This Service Information bulletin supersedes S.I. B63 05 03 dated October 2003.

Third Brake Lamp Cracked

E85 (Z4) from SOP to October 2003 production

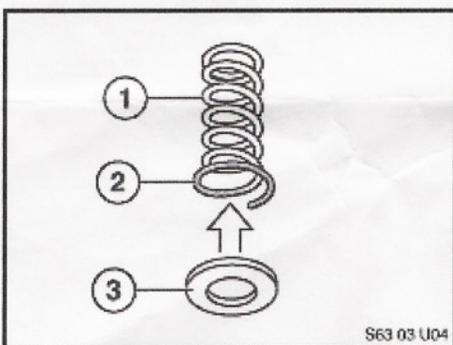
In case of customer complaint, when replacing the third brake lamp, replace the existing 82N springs with 40N springs plus an additional washer:

Temporarily hold the washer (3) in place on the spring (1) using dum-dum (or equivalent) applied to the area shown (2).

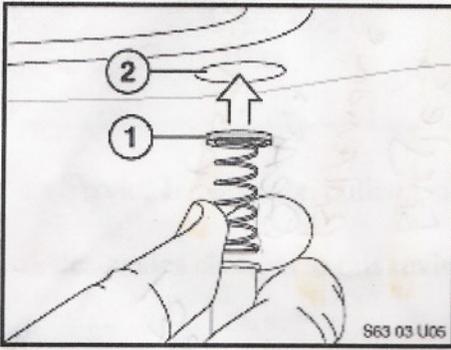
Using a nut driver, assemble the nut, spring and

washer (1) to the lamp mounting stud through the trunk panel hole (2) as shown.
